# 18-035AFDP – MCDONALD’S MENU SIGN

An Amended Final Development Plan (AFDP) for the installation of a digital menu board sign for an existing drive-thru restaurant.

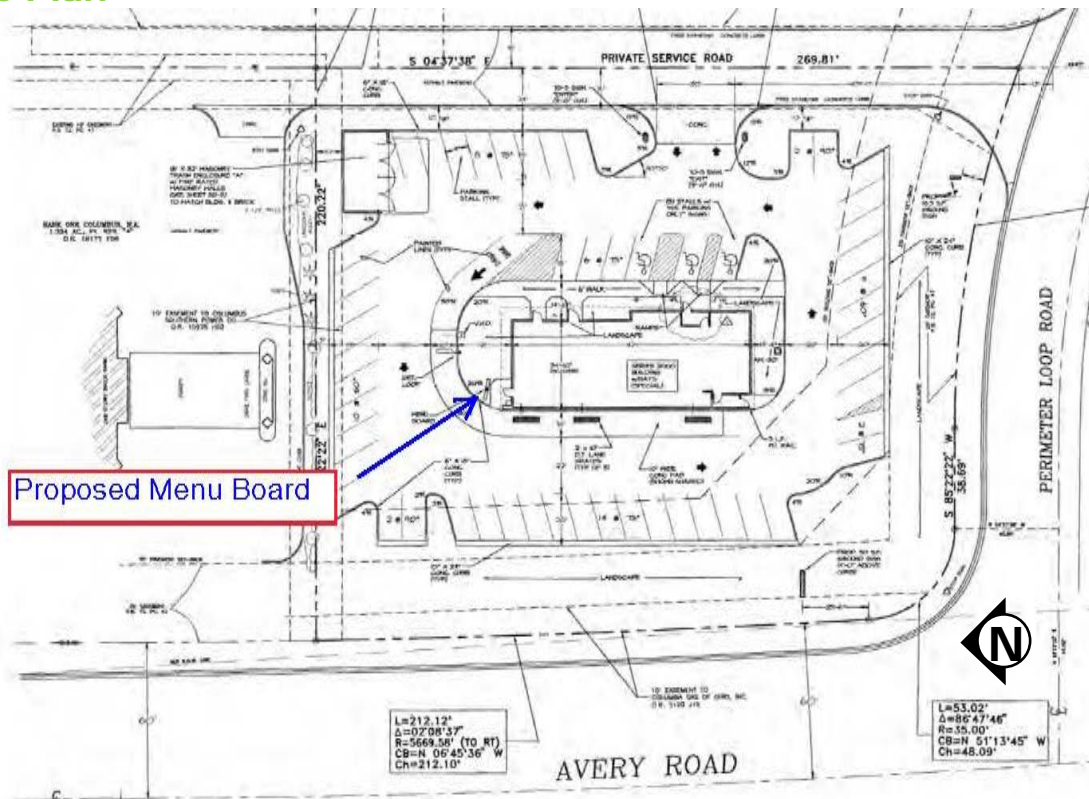
The development text for the Perimeter Center PCD does not contain any specific provisions for menu board signs. In lieu of the development text, the proposed sign would be subject to the standard sign code provision outlined in Zoning Code Sections 153.150 - 153.164. Zoning Code Section 153.161(N) outlines the regulations pertaining to drive-thru menu board signs which states "A drive-thru menu board sign is only permitted when all of the following conditions are fulfilled:

- (1) The sign is located on the property to which it refers;
- (2) The sign is not visible from the public right-of-way; and,
- (3) The sign does not exceed 32 square feet in size."

The proposed sign adheres to all three of the conditions listed and would therefore be permitted for this site.

These regulations prohibit the use of any electronic signage in addition to any signage that meets the definitions of flashing or animated as defined in the Dublin Sign Code, §153.150. These have been applied and enforced on all properties located within the Perimeter Center PCD.

Criteria not met. The proposal for a digital menu board sign does not comply with the general development standards that state no flashing, traveling, animated, or electrical signs are permitted within any subarea of the Perimeter Center PCD. This provision was included in the development text to ensure high quality sign standards were met for the development and those standards have been continuously upheld since the initial rezoning. As the proposed sign is in direct violation of the sign

regulations, the application is not consistent with the approved preliminary development plan. Should the Commission give consideration to permitting digital menu board signs, a text modification would be required for Subarea E of the development text allowing for the variation of sign standards per this application.
